## SEQUOYAH CONTAINMENT ANALYSIS

This letter report is in response to a request from the U.S. Nuclear Regulatory Commission to review and critique the ultimate strength analyses of the Sequoyah containment.

The description of the containment vessel and the analysis for review were provided in the NRC Information Report dated 22 April 1980, Ref. SECY-80-107A. The tasks requested in the work statement were as follows:

Figure 3. Stringer Effectiveness

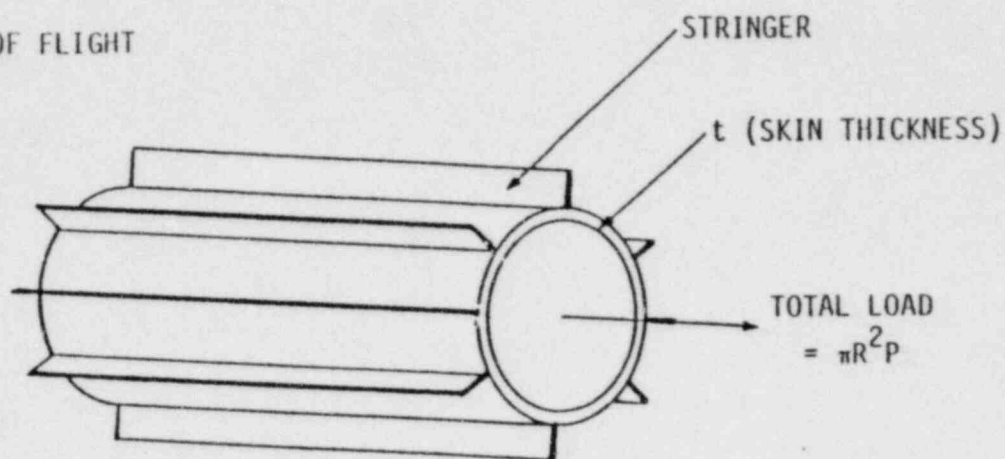
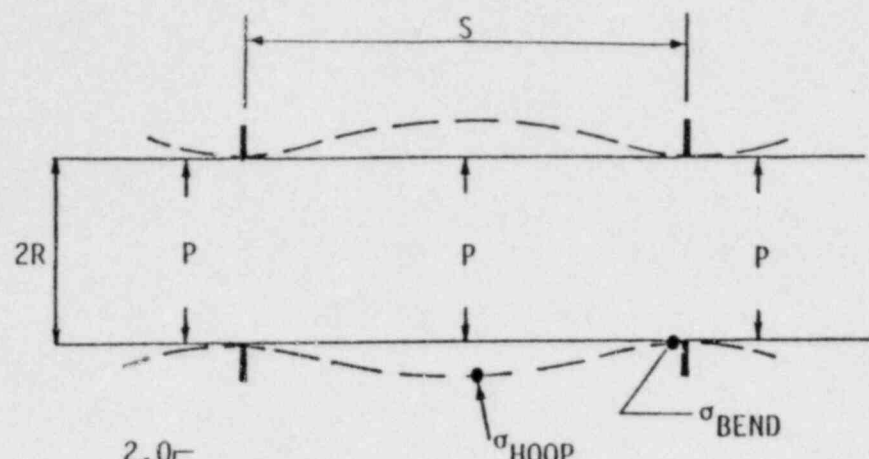
Following the method of Section 3 above and Figure 3 illustrates the application of the longitudinal stiffeners to the Sequoyah vessel. In calculating the meridional stresses an "effective" pressure is used, which is the internal pressure of the container less that pressure which is needed to support the structural weight above the section under consideration. Thus, at the critical 1/2 inch plate section (top of the cylinder) a dome weight of about 550,000 lb has to be supported and this is equivalent to an internal pressure of about 0.37 psi, and the internal pressure has to exceed this value before a meridional tension stress can be achieved. At the base the equivalent pressure to offset the overall weight of the container (about 2.3 million lb) is 1.54 psi.

It is seen from Figure 3 that the stringers are stressed to only about 40% of the amount of the meridional stress in the membrane. Of the total longitudinal load the membrane carries 93% and the stringers only 7%. It is therefore clearly incorrect to assume that the stringer cross sectional area can be "smeared" out fully over the membrane - the smearing technique can be used but by using about 40% of the stringer cross sectional area.

Figure 4. Ring Stiffener Effect

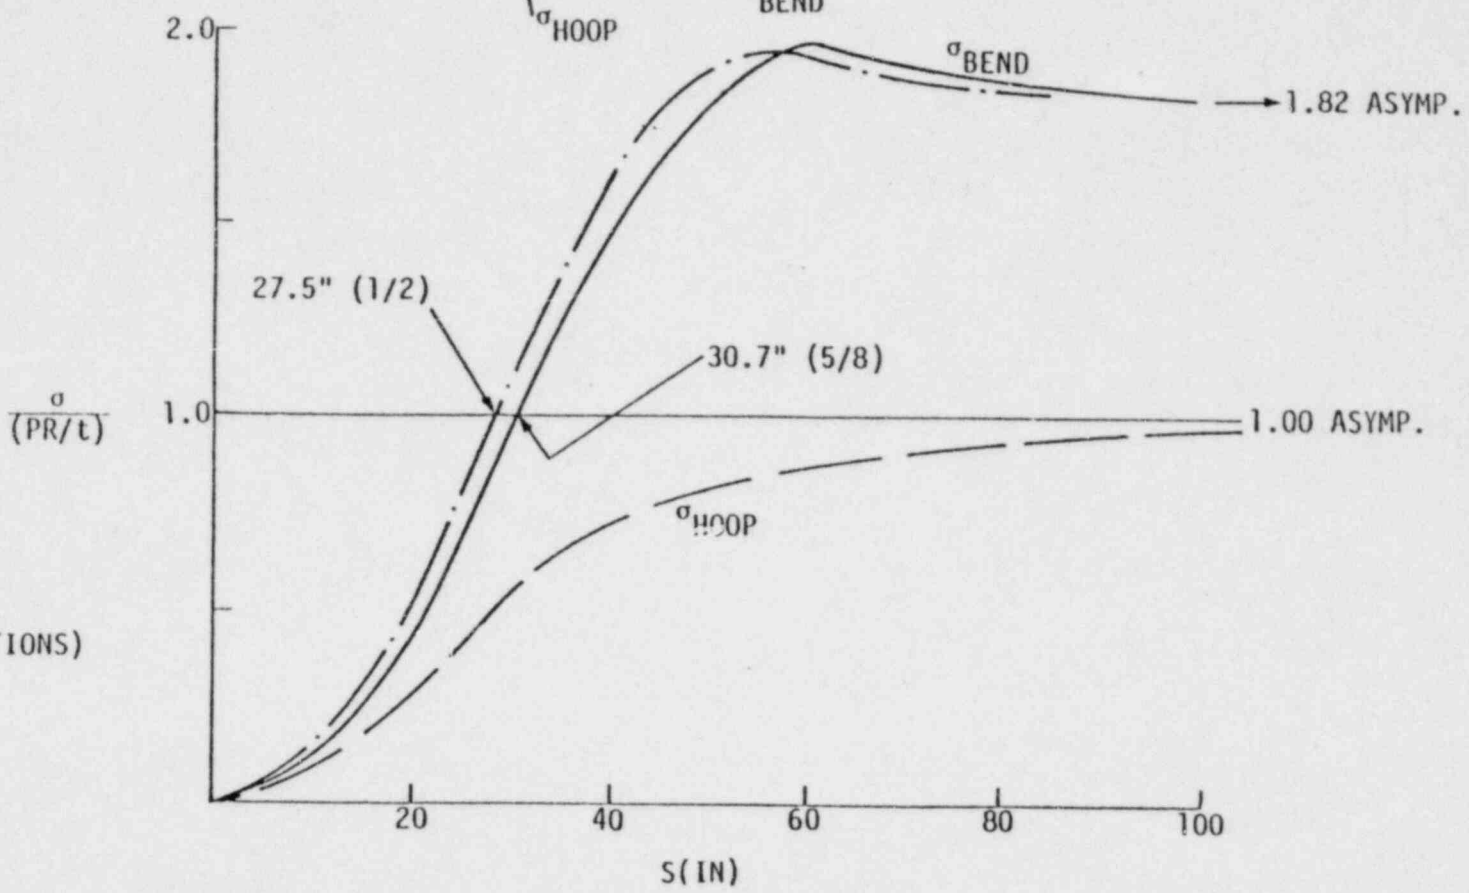
The analysis of thin walled cylinders with ring stiffeners is treated in detail in "Beams on Elastic Foundation" by M. Hetenyi (University of Michigan Press 1946) pages 83-84. Figure 4 shows the results of this analysis applied to the cylindrical section of the Sequoyah vessel. It is seen that the ring stiffeners have to be spaced very much closer than 80 inches to have any appreciable reduction on the membrane

hoop stress. Further local bending stresses at the attachment to the ring which are greater than the unmodified hoop stress are generated when the ring spacing is in excess of 27.5" to 20.7" (respectively for 1/2" and 5/8" plate). Since the actual design ring spacings are at 10 ft two conclusions may be drawn:

- a. Membrane hoop stresses in a considerable region between the ring stiffeners is for practical purposes not influenced by the ring stiffeners.
- b. A local bending stress at the ring attachment to the shell is induced and this stress is some 80% higher than the simple membrane hoop stress.

Thus, the critical region for hoop stress will be the 1/2 inch plate midway between the two rings. (This occurs between rings at elevations 778.5 and 788.0 shown in Figure 1). This section has the upper 2/3 of 1/2 inch plate and the lower 1/3 of 5/8 inch plate, and hence the mid-section area of criticality is in the 1/2 inch plate). In this case the critical internal pressure may be calculated as follows:

Figure 5. Panel Arrangement

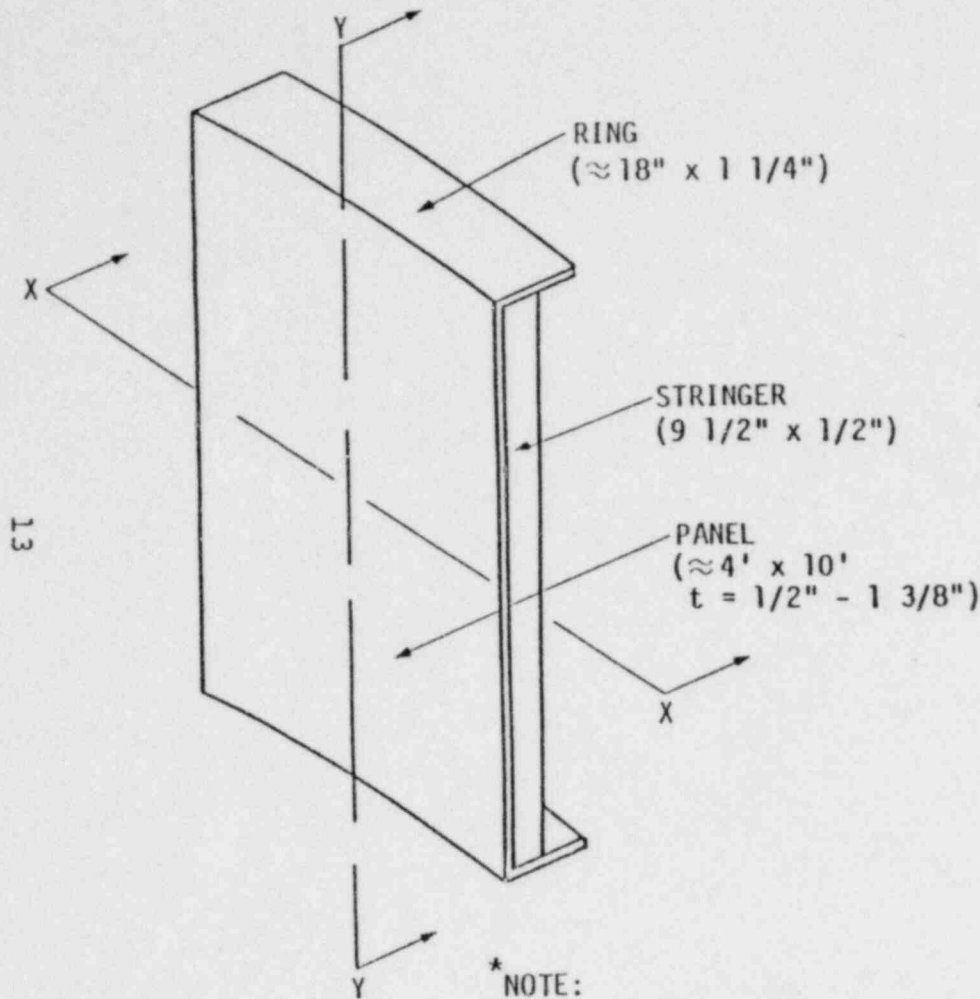
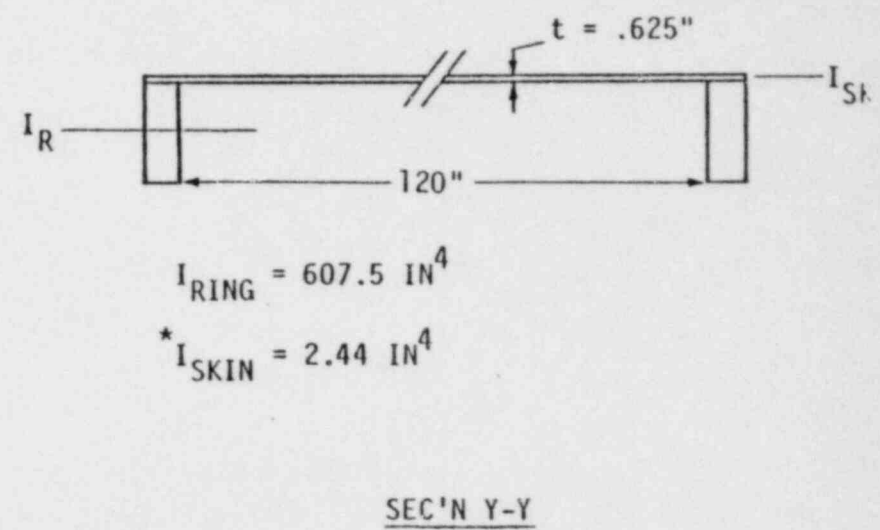
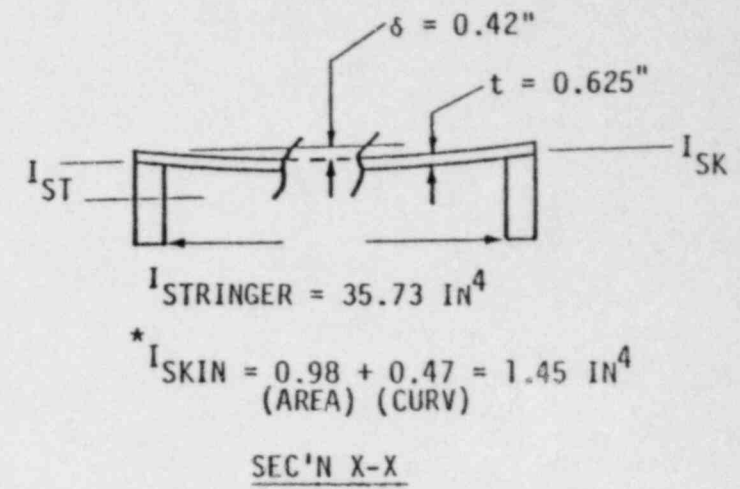
An alternative approach, in order to determine local stress regions induced by the rings and stringers, is to consider the cylinder to be a number of rectangular panels framed by ring sectors and stringer sections as shown in Figure 5. Thus, the cylinder is composed of a number of panels approximately 4 ft by 10 ft as shown with thicknesses varying from 1/2 in. to 1 3/8 in. A comparison of the bending stiffness of the panel and the rings and stringers is shown in Figure 5. The cross sectional moment of inertia about the bending axis is a measure of the stiffness of a beam. In the case of a panel bending as a beam there is an additional term due to a Poisson's Ratio ( $\mu$ ) contribution. This is, however, only a 10% effect (proportional to  $1 - \mu^2$ , and  $\mu = 0.27$ ) and is neglected in calculating the moment of inertia of the panel.

From Figure 5 it is seen that in bending about the XX axis the stringers are over twenty times as stiff as the skin, even though the skin is curved across the bending axis thereby increasing its effective moment of inertia by some 50%. For bending about the longitudinal axis YY the relative stiffness

is even higher (about 250 to 1). The analysis of Figure 5 were carried out for a 5/8 inch thick skin. The relative stiffness will be even higher for a 1/2 inch thick skin since the skin moment of inertia involves a  $t^3$  term.

Figure 6. Flat Plate Analysis

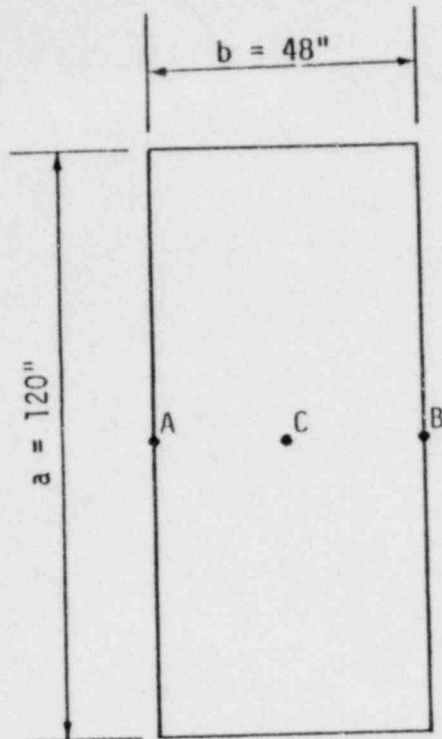
This is presented in Figure 6. For an encastré edged plate Table 8a on page 392 of the reference volume gives a value for the maximum bending stress at A & B (the midpoints of the long sides) as  $\sigma = 0.5 P b^2 / t^2$ . For the plate under consideration this gives initial stresses for yielding at a pressure of 6.94 psi. At this pressure the inner plate fibers at A & B will just begin to yield in tension, and the outer plate fibers in these locations will be compressed to a stress of 32,000 psi. At a value of about 1.5 times this pressure (or 10.4 psi) yielding will occur through the entire plate section at A & B. (This is known as a "plastic hinge"). Ultimate yielding stresses of the surface fibers at A & B will be reached at a pressure of 13.0 psi.

The table, referenced above, shows that the stress at the midpoint of the plate (C in Figure 6) is half that occurring at A & B, and is in the opposite sense (i.e., tensile on the outside, compression on the inside). However the plate is not

Figure 7. Large Deflection Flat Plate Analysis  
("Quilting Effect")

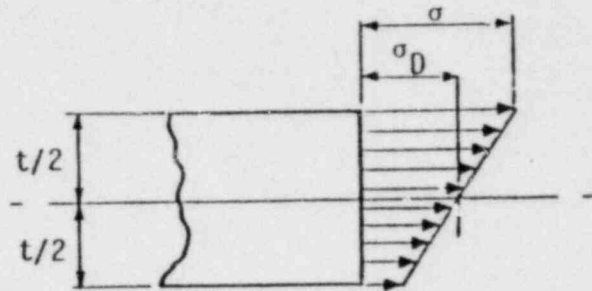
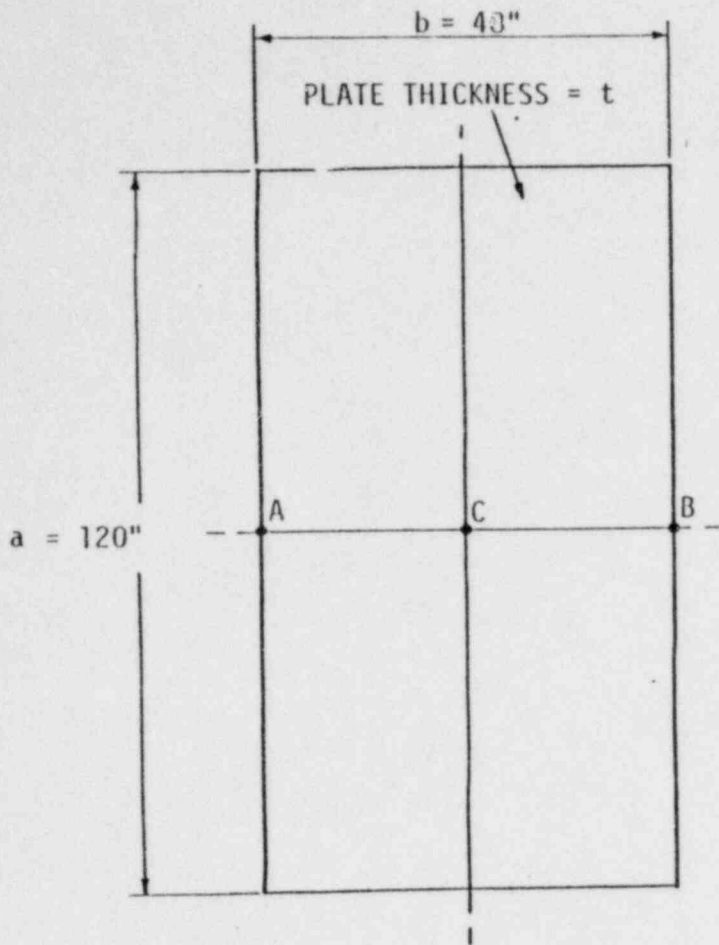
The analysis of (a) assumes a flat plate and makes no allowance for the finite deflections of the plate. The formula of page 408 of the referenced work makes allowance for the plate deflection. These results are summarized in Figure 7. Again maximum stresses occur at the midpoints of the long sides. The resulting stress is a combination of bending and membrane stresses. Yielding (at 32,000 psi stress) of the inner fibers at A & B begins at an internal pressure of 7.8 psi. Only 6 1/2% of the total stress is due to the membrane contribution.

The onset of yield could occur at the inner fibers at the midpoints of the long edges of the half inch plate sections at an internal pressure of 7.8 psi, assuming the more realistic "quilting" analysis. However, this is at local points only and full plastic hinging would not occur until about 11.7 psi. Even then local stress relief might well occur and for a "one-shot" pressurization it is not clear whether this would result in leakage. It would be a serious problem if many cycles of pressurization were encountered when cracking due to "LCF" (low cycle fatigue) might well occur. More serious, however, is the pure membrane stress induced in the 1/2 inch skin at 26.8 psi. This is a tension over the whole cross section of the panel and would occur over several inches of the vertical panel centerline.

Figure 8. Hold Down Bolt Stresses

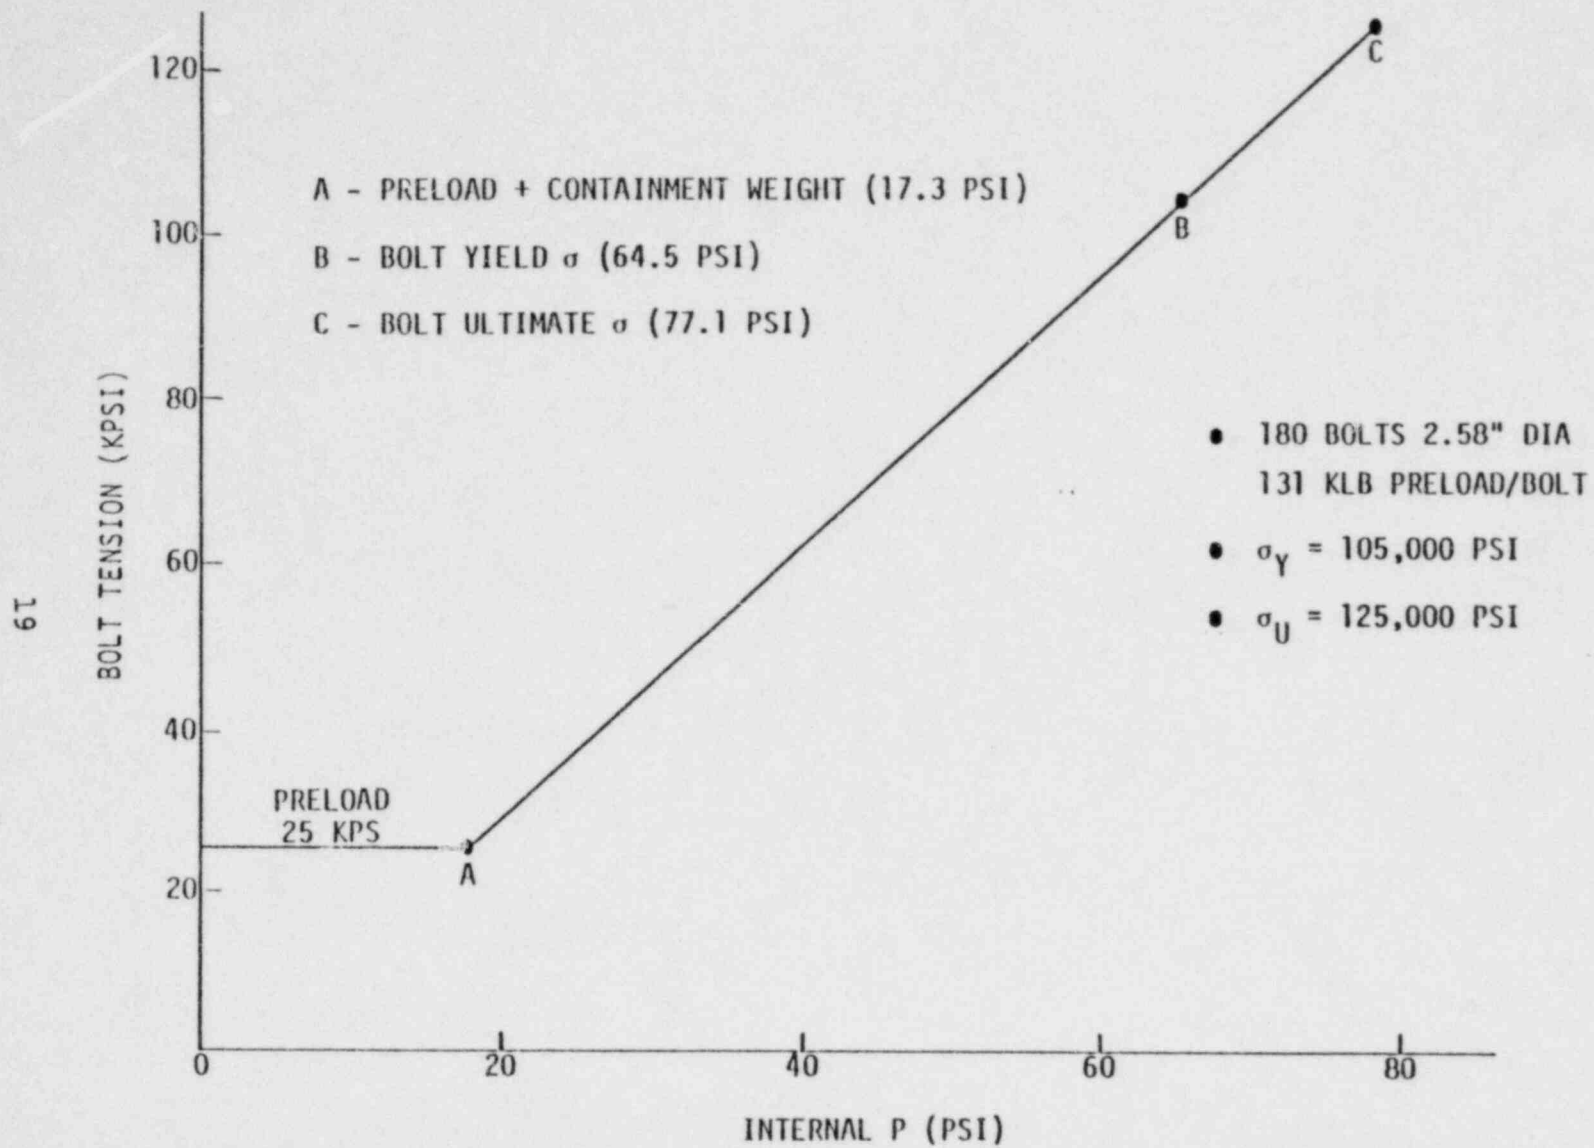
Figure 8 depicts the tension stress in the hold down bolts as the internal pressure is increased. The bolts are pre-stressed to a level of 25,000 psi and this bolt tension is not increased until the internal pressure overcomes the container weight as well as the preload tension. This occurs at an internal pressure of 17.3 psi. Increasing pressure will produce bolt yield stress at 64.5 psi and the ultimate bolt stress of 125,000 psi would be reached at an internal pressure of 77.1 psi. The latter, however, could not realistically be achieved since gross leakage would occur as soon as the bolts yield.
